## **Addendum No. 2**

Re: Laun Park – Splash Pad Improvements

Project #PR-079-22

Date: July 22, 2024

**1 NEW WORK SITE PLAN**

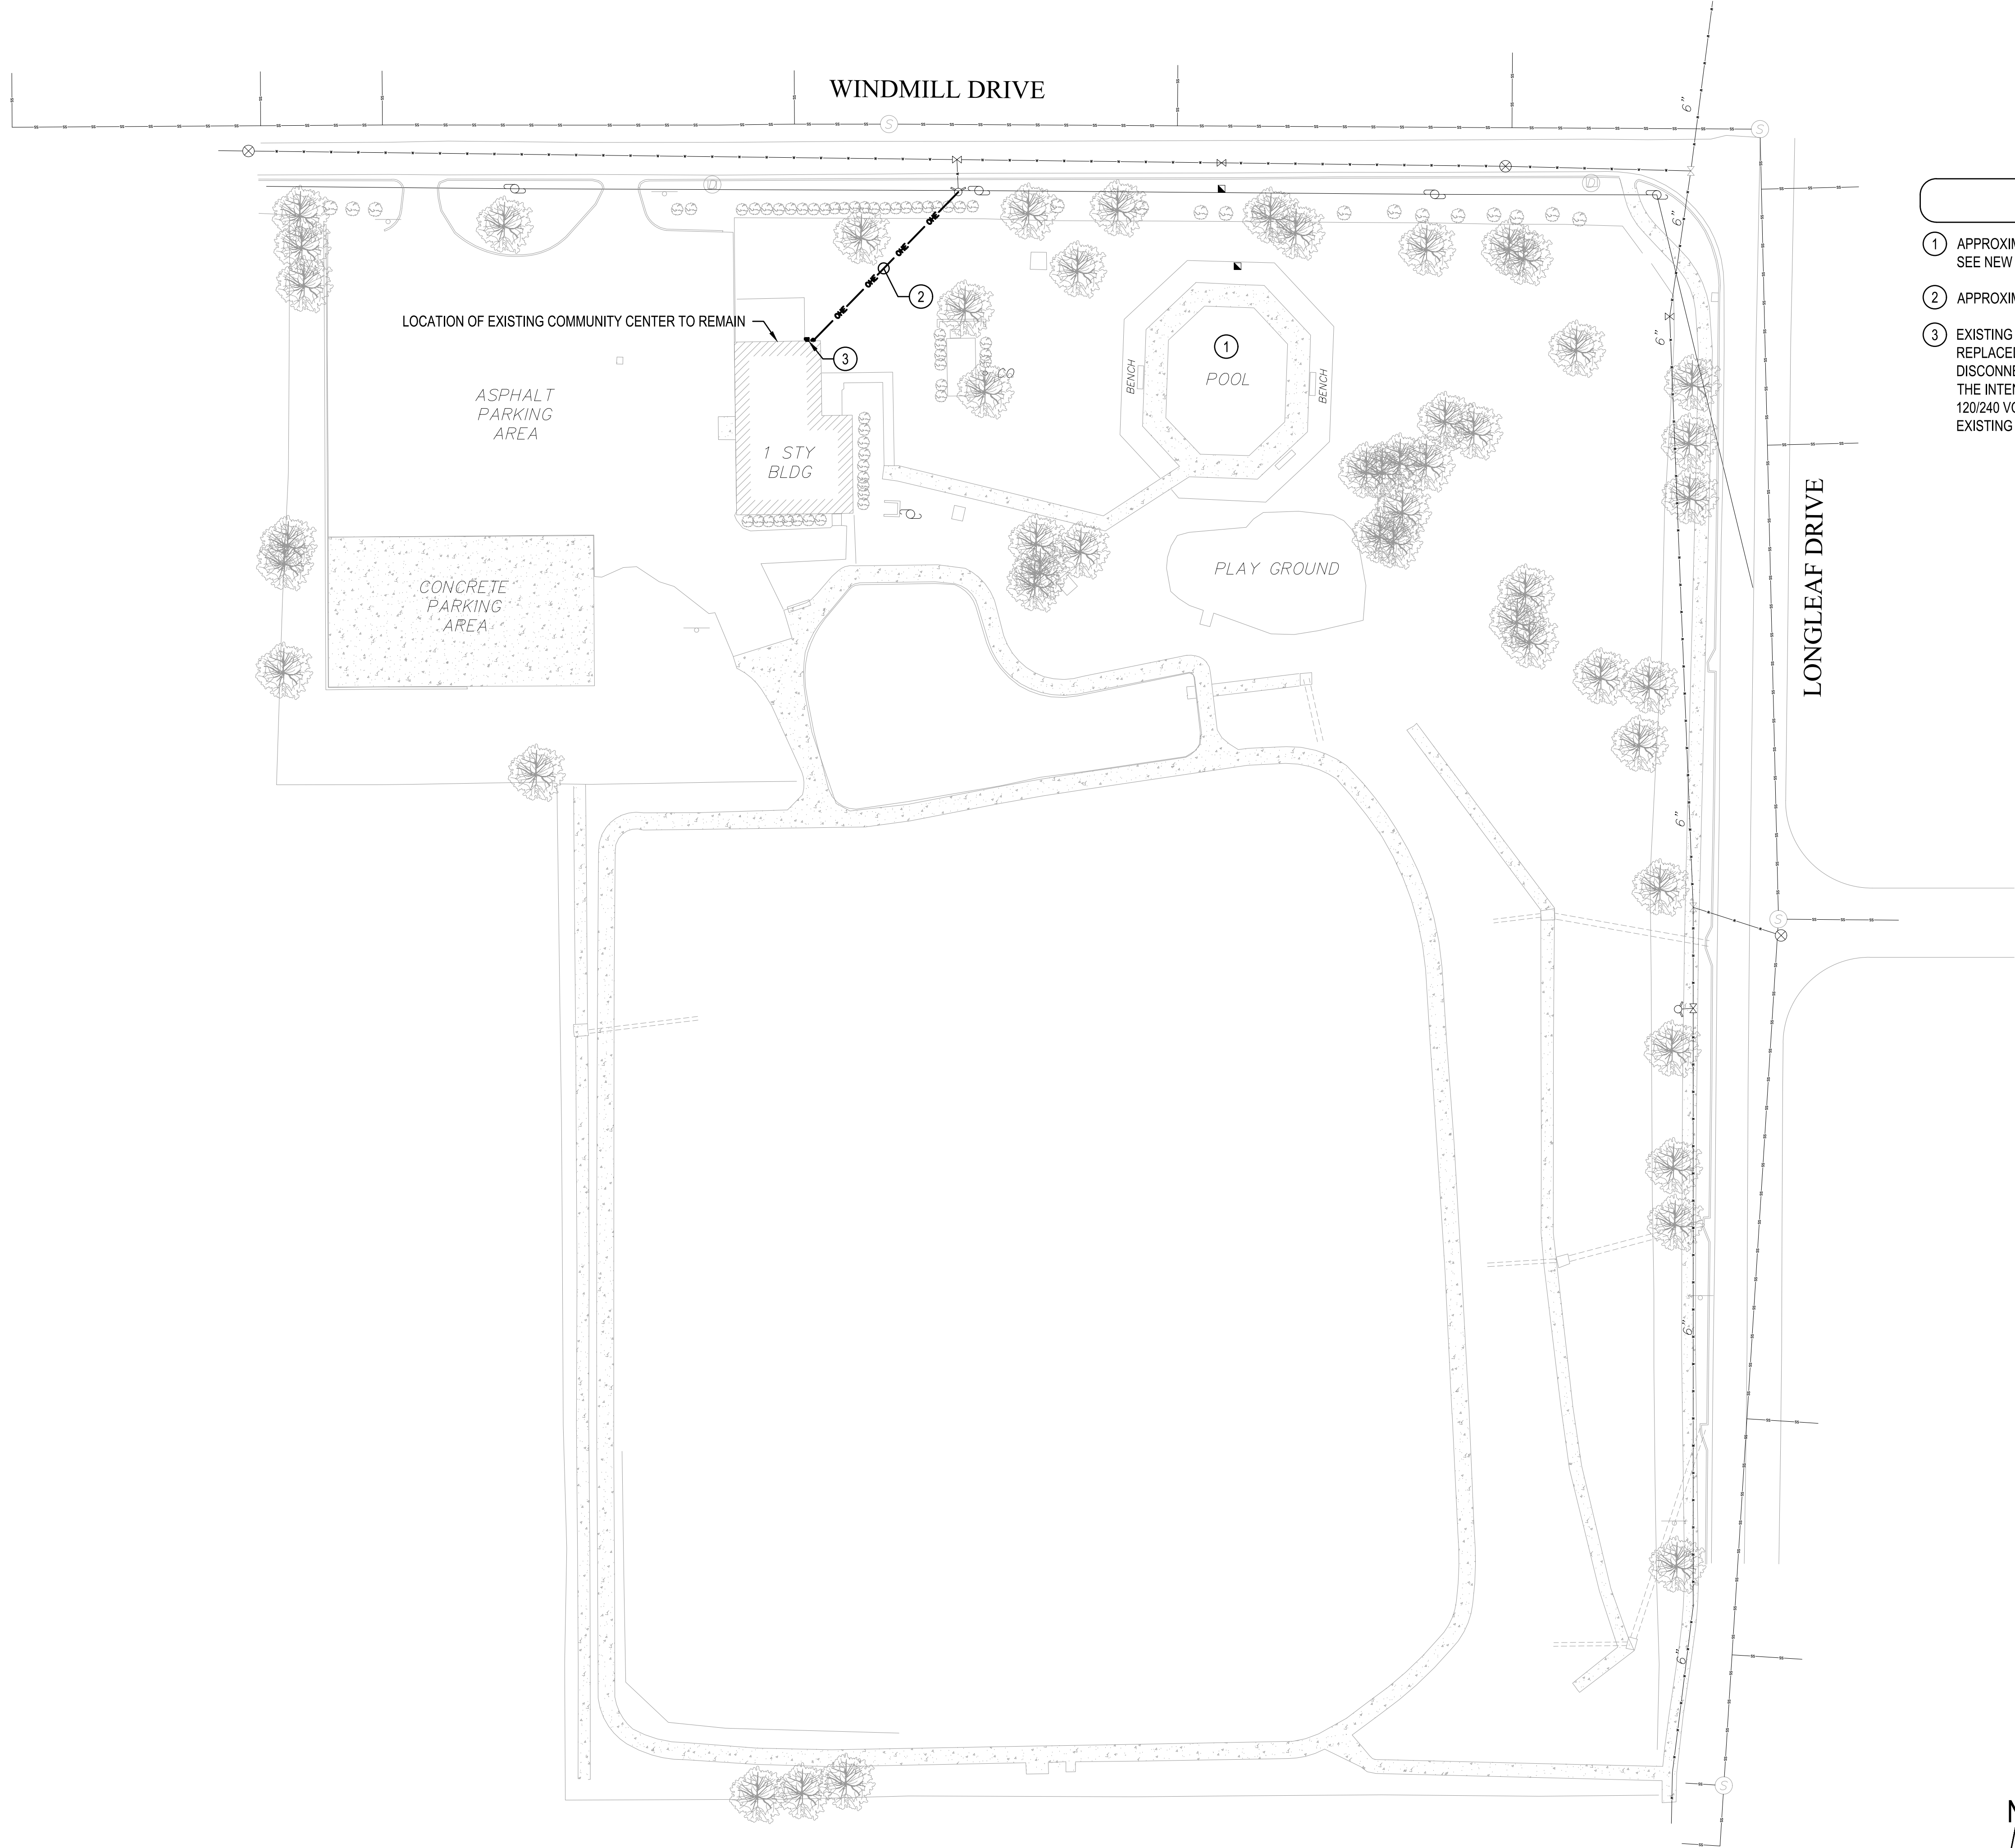
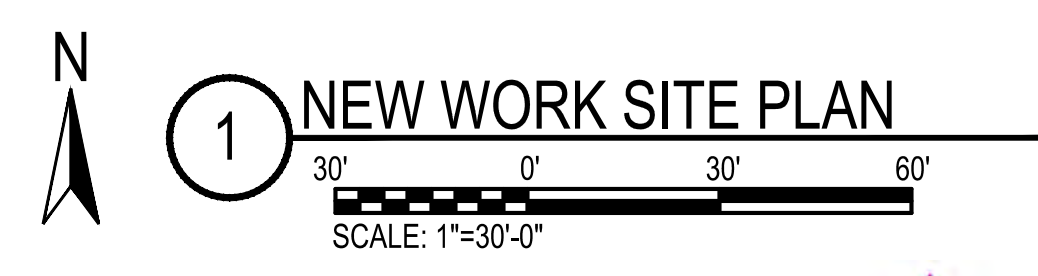
- Item 1. The bid Due Date has been changed to July 31, 2024. All other bidding instructions to remain the same.
- Item 2. Addendum #1 RFI #1 question, “Do you have any requirements on what size and voltage feed is required for the Splashpad controller?”, further clarified in attached drawings, with updates dated July 22, 2024, and should be used to bid electrical portion of project.

- 2 THE CONTRACTOR SHALL BORE FROM THE NEW PANEL 2MDP LOCATED AT THE COMMUNITY CENTER BUILDING TO THE NEW SPLASHPAD CONTROL UNIT. THE ELECTRICAL CONTRACTOR IS TO PROVIDE AND INSTALL 3#8, 1#10G, 1-1/2" CONDUIT TO SERVE THE NEW CONTROL UNIT FOR THE NEW SPLASHPAD. THE CONDUIT SHALL BE PVC BELOW GRADE AND GRS ABOVE GRADE. THE TRANSITION FROM PVC TO GRS SHALL OCCUR BELOW GRADE. THE ELECTRICAL CONTRACTOR SHALL COORDINATE FINAL ROUTE PRIOR TO BEGINNING ANY WORK TO AVOID CONFLICT WITH EXISTING TREE ROOT SYSTEM, OTHER UTILITIES, EXISTING BUILDINGS, ETC..

- 3 FINAL LOCATION AND POWER REQUIREMENTS OF NEW SPLASHPAD CONTROLLER TO BE FIELD COORDINATED WITH EQUIPMENT PROVIDER / INSTALLER PRIOR TO BEGINNING ANY SPLASHPAD WORK AND ADJUSTED AS REQUIRED.
